Architectural Review Board Agenda
4:00 PM Wednesday, August 6, 2025
Sussex Civic Center – Committee Room Second Floor

MEMORANDUM

TO: Architectural Review Board
 FROM: Gabriel Gilbertson, Community Development Director
 RE: August 6, 2025 Architectural Review Board
 DATE: Friday, August 1, 2025

Client / Location or Project / Sign Classification / Version# or Sheet / Revision# / Drawing Status
Dynamic_Ratings_MON_v03_r01_D

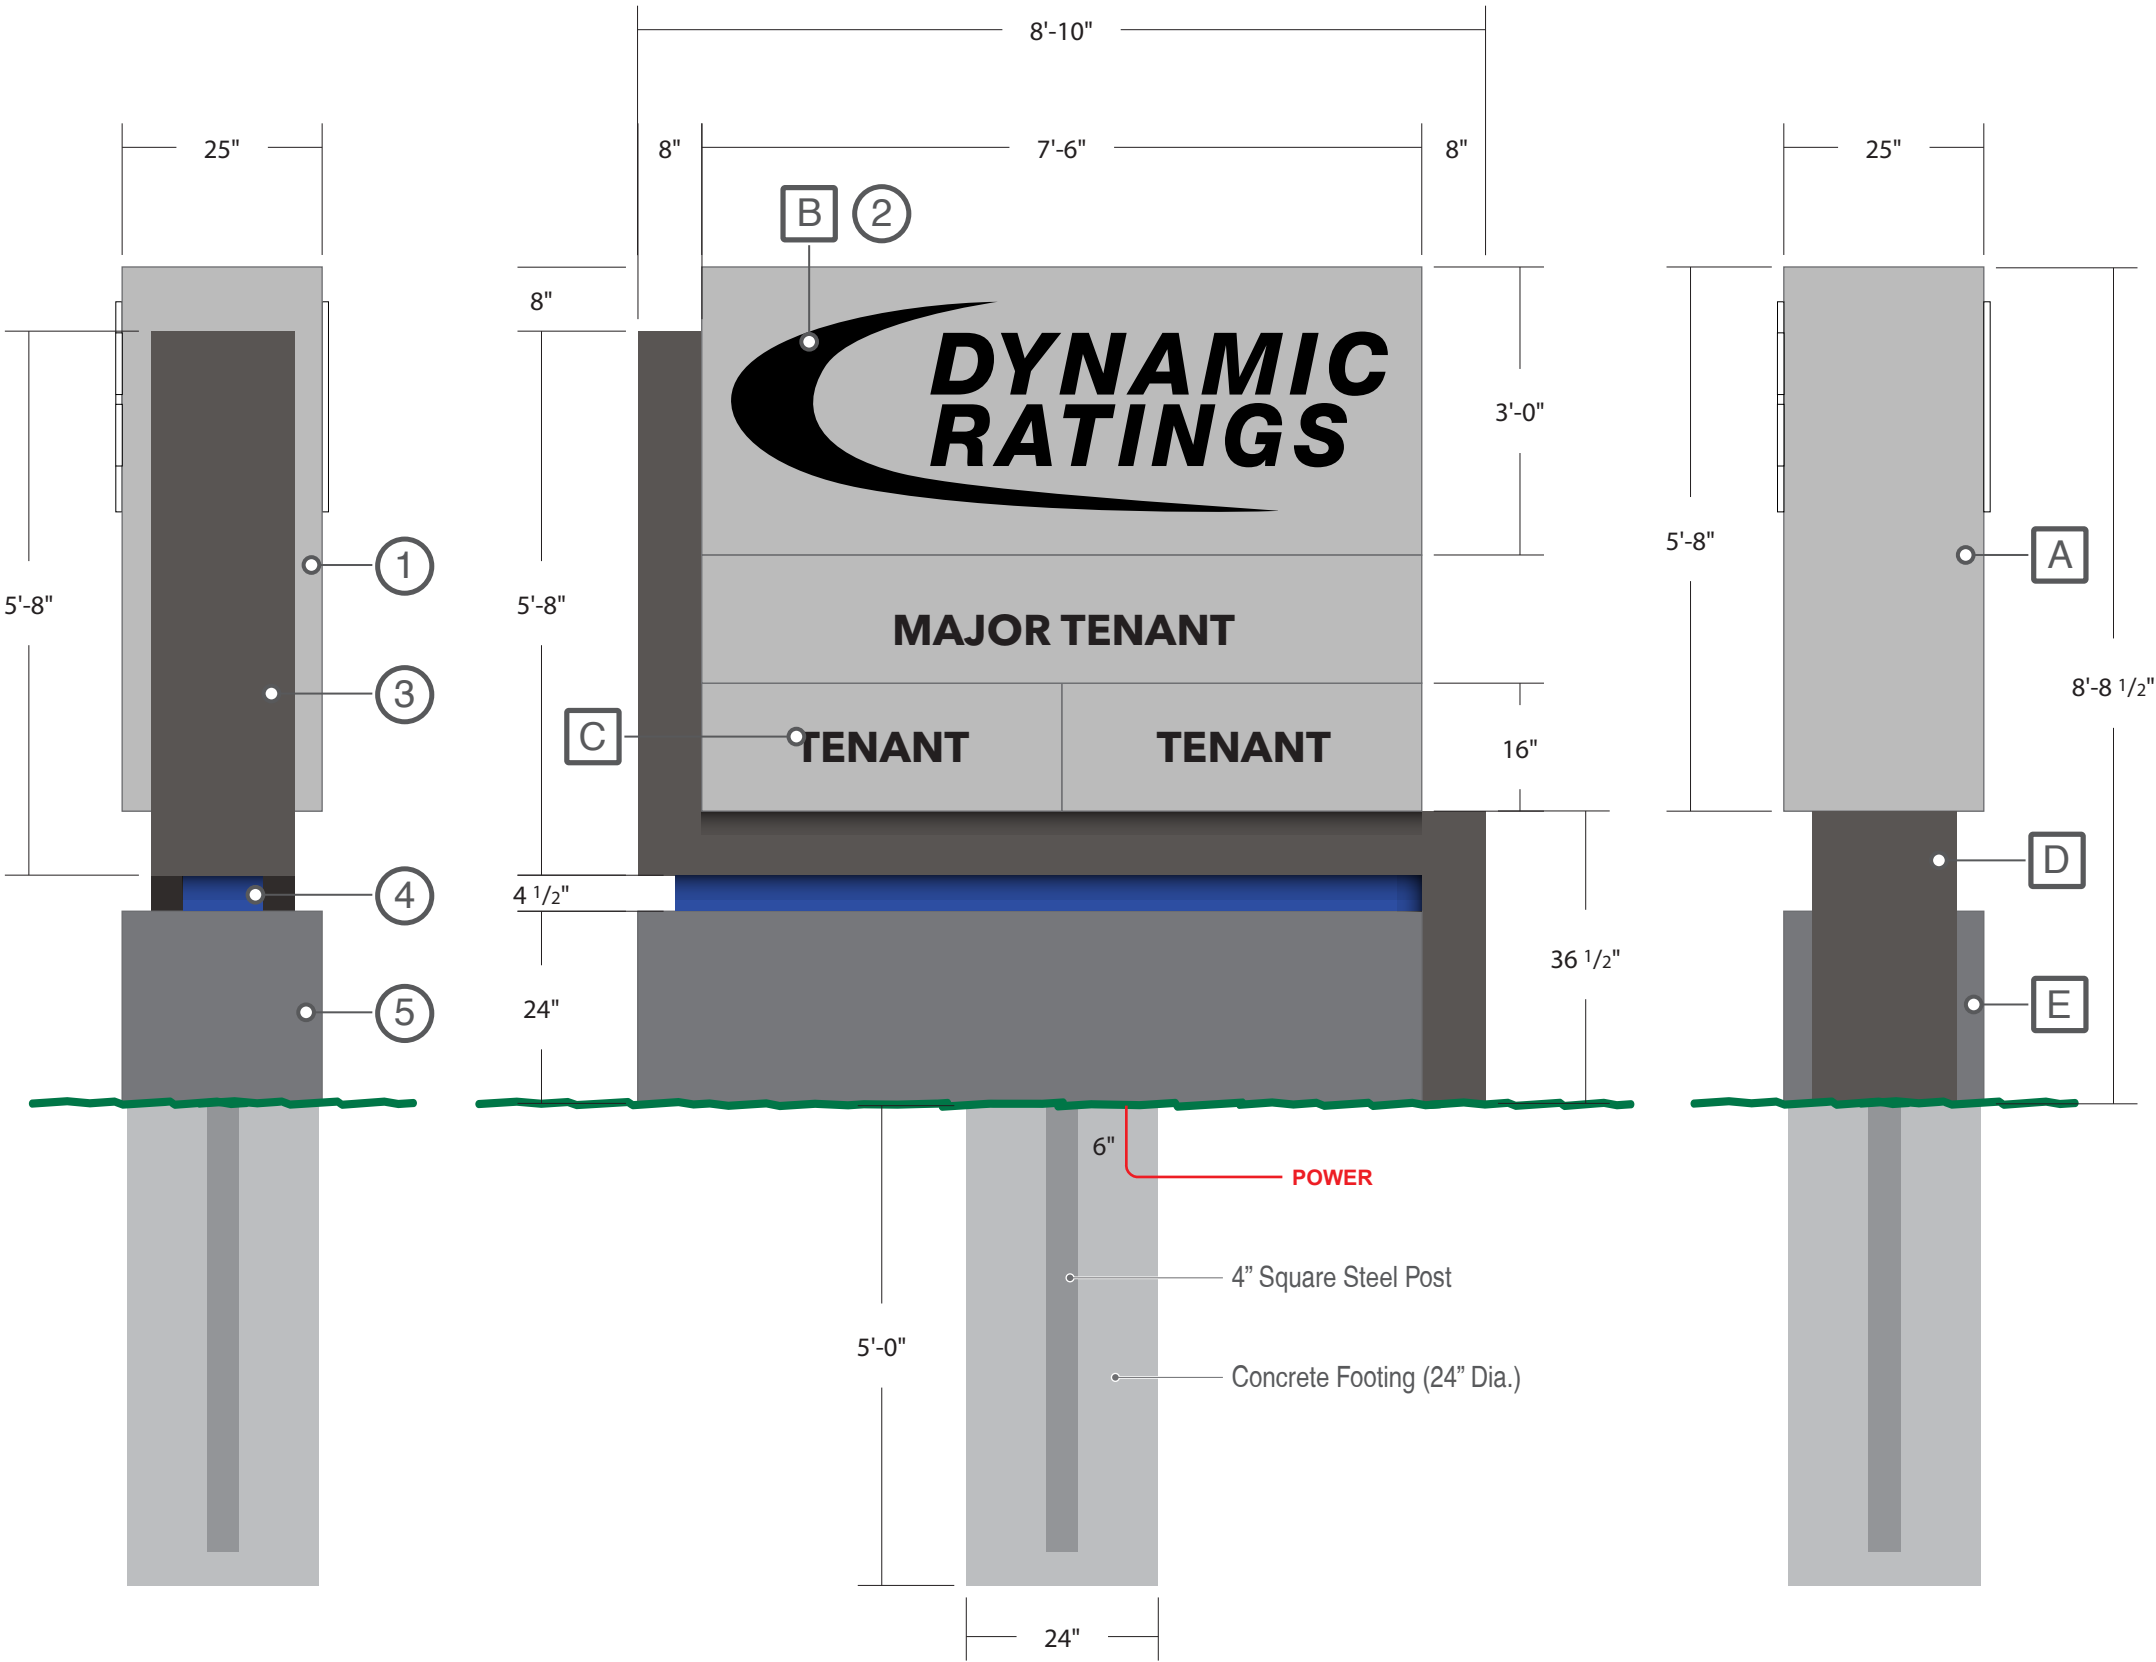
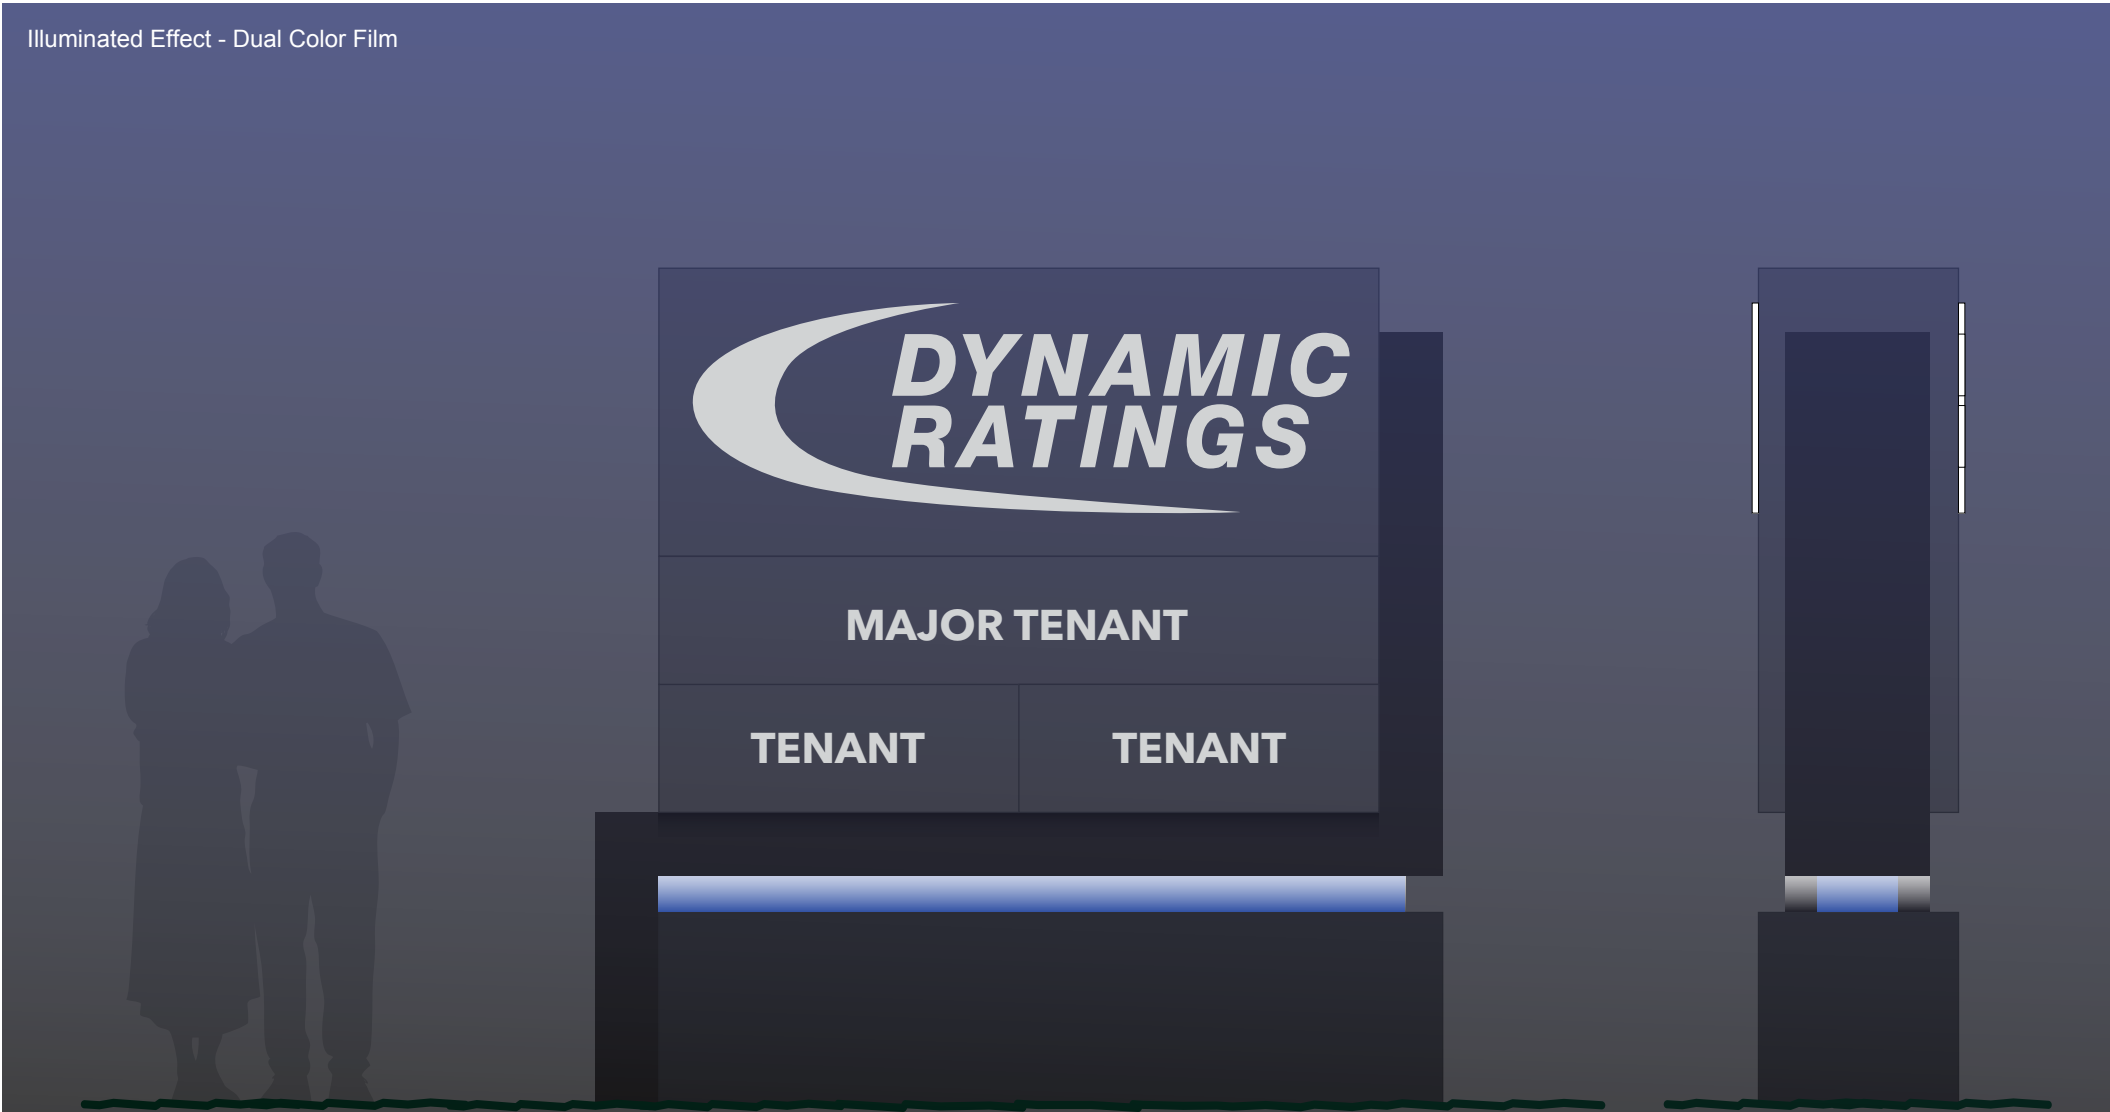
A sign permit application was submitted for Dynamic Ratings for a monument sign for their new building located at the subject property. The Sussex Design Standards require monument signs to be constructed of and framed with natural materials unless otherwise approved by the Architectural Review Board. The applicant has submitted a monument sign, that while being architecturally similar to the building, has an aluminum base and sign cabinet without being framed or constructed of natural materials.

1. The ARB will need to discuss if the Board is comfortable approving the submitted sign although it does not conform to the Sussex Design Standards.

Please view the drawings to note original drawing that Lemberg/Dynamic Rating seeks approval for is a aluminum monument base. The aluminum monument base is cost effective and presents a clean look to the ground sign. The original design has been influenced by the design of the west elevation. Lemberg/Dynamic Rating seeks approval of this design despite the adherence to the natural material requirement.
